SUBJECT: COMANCHE PEAK NUCLEAR POWER PLANT, UNITS 3 AND 4
DOCKET NUMBERS 52-034 AND 52-035
RESPONSE TO REQUEST FOR ADDITIONAL INFORMATION 275 (7099)
(SECTION 3.4.1)

RESPONSE TO REQUEST FOR ADDITIONAL INFORMATION

RAI 275 (7099)

QUESTION NO.: 03.04.01-1

Flow Paths from Tank Houses

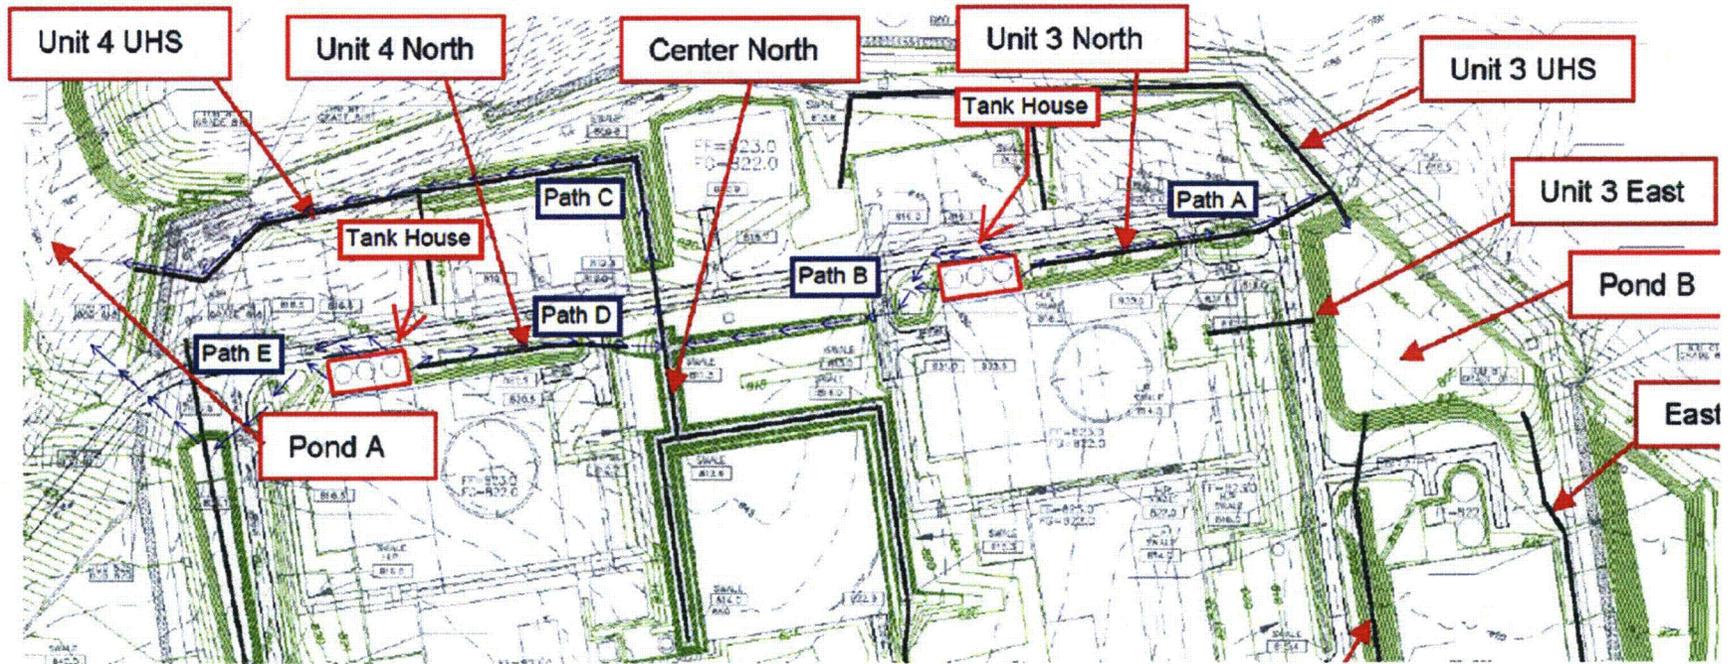
- a. Specifically address the failure of the exterior tanks associated with the condensate storage facilities, (CST, DWST, and PMWTs) in the FSAR, and provide the basis for the conclusion that water released due to failure of these tanks would flow away from the plant and not impact safety-related SSCs.
- b. Identify this COL item as a Comanche Peak COL item instead of a Standard COL item since it is based on site specific location of the external tanks.

As shown in FSAR Figure 1.2-1R (Sheet 2 of 2), two PMWTs and one RWSAT are located inside each Tank House, which is located north of the auxiliary building. The capacities of one PMWT and the RWSAT are 140,000 gallons and 220,000 gallons, respectively. The PMWTs and RWSAT are surrounded by concrete curbs inside the Tank House that are designed to retain the entire water volume of all three tanks. Therefore, failure of two PMWTs and the RWSAT in a unit does not jeopardize any safety-related equipment. However, since the concrete curbs are not seismically qualified, they cannot be credited for a seismic event, although they can be credited for tornado/hurricane missiles. As depicted in FSAR Figure 2.4.2-202 and Figure 2.4.2-206, there are several grading and drainage features in the area of the Tank Houses. See Attachment 1 for the flow paths from the Tank Houses. If the curb is not credited due to a seismic event, the flow path from the Unit 3 PMWTs and RWSAT could be Path A and/or Path B. Path A flows to Drainage Pond B, while Path B merges into Path C and flows to Drainage Pond A. Also, the flow path from Unit 4 PMWTs and RWSAT could be Path D and/or Path E. Path D merges into Path C and flows to Drainage Pond A, while Path E flows directly to Drainage Pond A. Therefore, even if the concrete curbs inside the Tank Houses are non-functional due to a seismic event, the released water would be directed to Drainage Pond A or Drainage Pond B.

Drainage Pond A is normally empty and has a bottom elevation of approximately 798.9 ft msl. Drainage Pond A has a capacity of approximately 7,300,000 gallons at the overflow elevation of approximately 810 ft msl. The top berm elevation of Drainage Pond A is approximately 813 ft msl, so the overflow capacity of Drainage Pond A is much greater than 7,300,000 gallons.

Drainage Pond B has a bottom elevation of approximately 804 ft msl and an overflow elevation of approximately 811 ft msl. Drainage Pond B is normally empty and has a capacity of approximately 2,700,000 gallons. The top berm elevation of Drainage Pond B is approximately 814 ft msl, so its overflow capacity is much greater than 2,700,000 gallons.

Therefore, the entire water volume from all Unit 3 and 4 PMWTs and RWSATs can be retained within Drainage Pond A and Drainage Pond B, even if the runoff feature of Drainage Pond A or Drainage Pond B is postulated to be non-functional.

Flow Paths from Condensate Storage Tanks

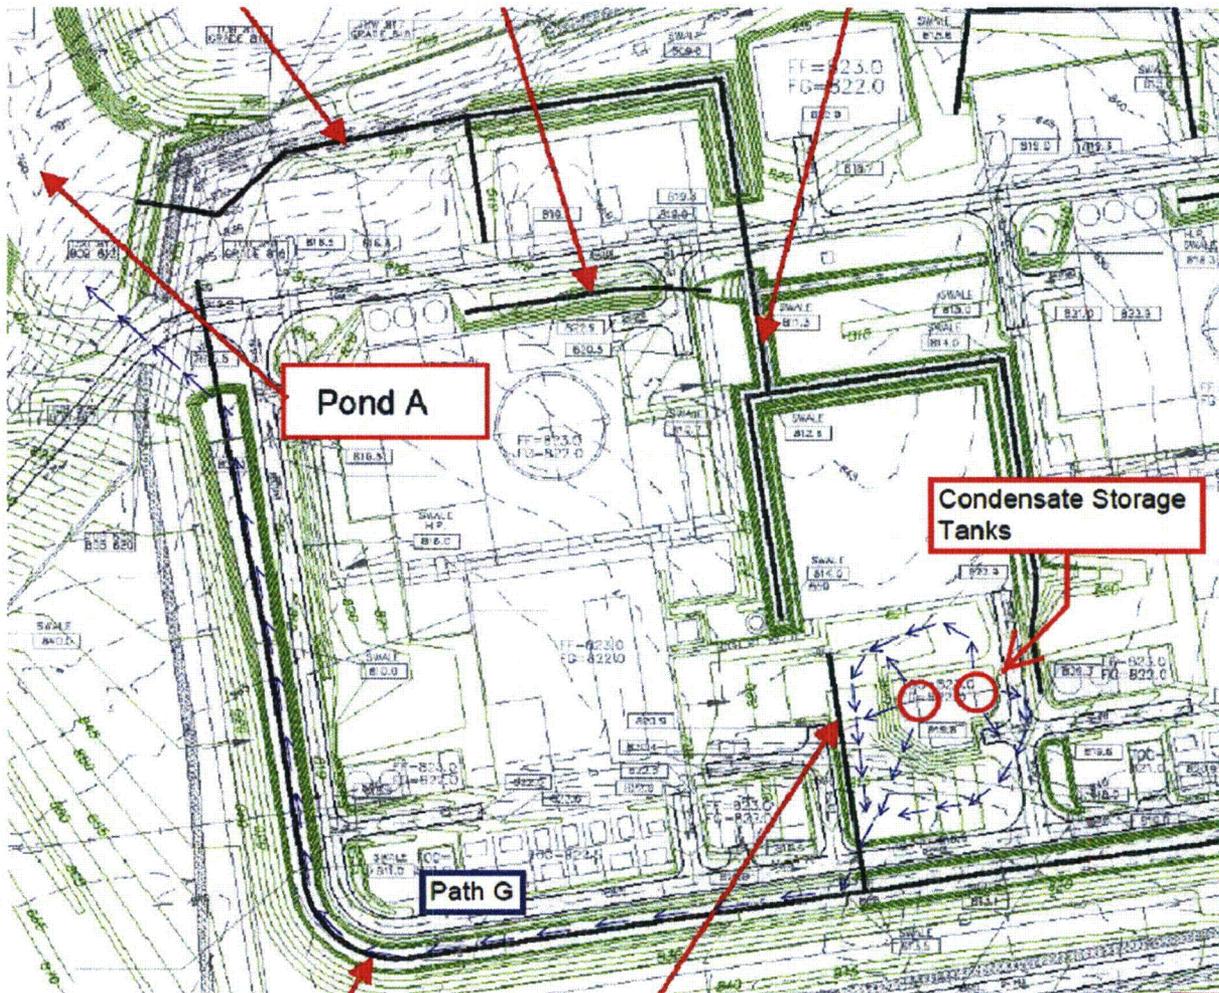
US-APWR DCD COL item COL 3.4(3) states "Site-specific flooding hazards from engineered features, such as from cooling water system piping, are to be addressed by the COL applicant". Upon review of the site plan drawings the staff found that there are two 750,000 gallon non-seismic condensate storage tanks (CSTs), surrounded by non-seismic dikes located outside the turbine building which puts them in close proximity of safety-related structures, systems, and components (SSCs). SRP 3.4.1 "internal flood protection for onsite equipment failures" identifies failure of exterior tanks as an area of review. Therefore the staff's review of internal flooding takes into consideration the effects of potential flooding of SSC's due to failure of non-seismic and non-tornado protected tanks, vessels, and other process equipment. The applicant does not address the failure of the condensate storage tanks in the supplemental information added to the FSAR to address COL item 3.4(3). However, in addressing COL item 3.4(1) it is stated in the FSAR that

Based on the location of the CST relative to the plant, the staff could not confirm the water released from the failure of the CSTs would be drained away from the plant. Also, the COL item in the FSAR addressing failure of these tanks is identified as a standard COL item (SCOL). Since the number and location of condensate storage tanks in the yard are site dependent, the COL item related to this should be a site specific COL item (CP COL).

Two CSTs are located at an elevation of 822 ft msl between the Unit 3 and Unit 4 Turbine Buildings. The CSTs are approximately 280 ft west of the Unit 3 PSFSV and approximately 300 ft east of the Unit 4 PSFSV, which are the nearest safety-related structures. The capacity of a CST is 750,000 gallons. As depicted in FSAR Figure 2.4.2-202 and Figure 2.4.2-206, the grade is sloped downhill around the CSTs, directing leakage from the CST to the nearest valley located southwest of the CSTs. Overflow from this valley will ultimately discharge into Drainage Pond A via a 620 ft by 30 ft swale. See Attachment 3 for the flow path from the CSTs, which is Path G. The capacity of Drainage Pond A is much greater than 7,300,000 gallons as presented above. Therefore, the entire water volume from the CSTs can be retained within Drainage Pond A even if

the runoff feeder of Drainage Pond A is postulated to be non-functional. Thus, the failure of the CSTs does not jeopardize safety-related equipment.
